UNITED STATES PATENT AND TRADEMARK OFFICE

APPLICATION NO.	FILING DATE	FIRST NAMED INVENTOR	ATTORNEY DOCKET NO.	CONFIRMATION NO.
09/678,423	10/02/2000	John M Boyd	LAM2P206	4367

Office Action Summary

DETAILED ACTION

FIG. 2A-1

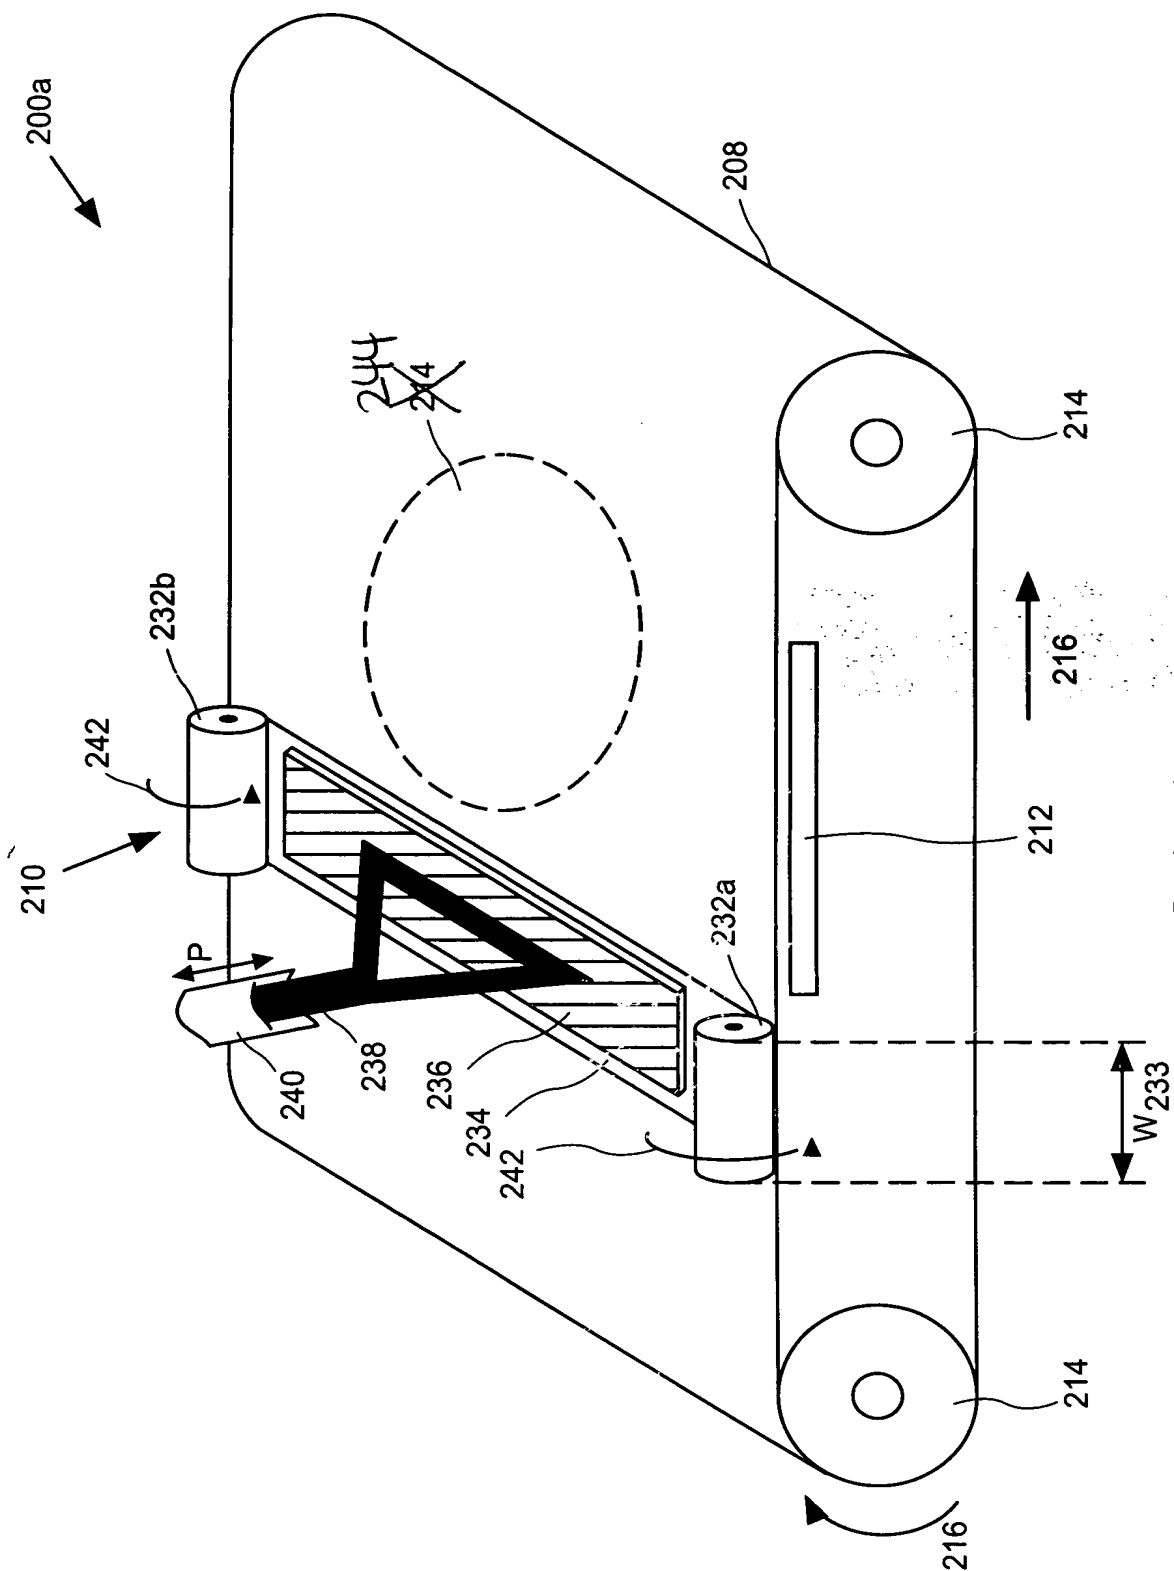
- 9) ☐ The specification is objected to by the Examiner.
- 10) ☐ The drawing(s) filed on ____ is/are: a) ☐ accepted or b) ☐ objected to by the Examiner.
Applicant may not request that any objection to the drawing(s) be held in abeyance. See 37 CFR 1.85(a).
- 11) ☒ The proposed drawing correction filed on 19 July 2002 is: a) ☒ approved b) ☐ disapproved by the Examiner.
If approved, corrected drawings are required in reply to this Office action.
- 12) ☐ The oath or declaration is objected to by the Examiner.

APPROVED
 9/4/02
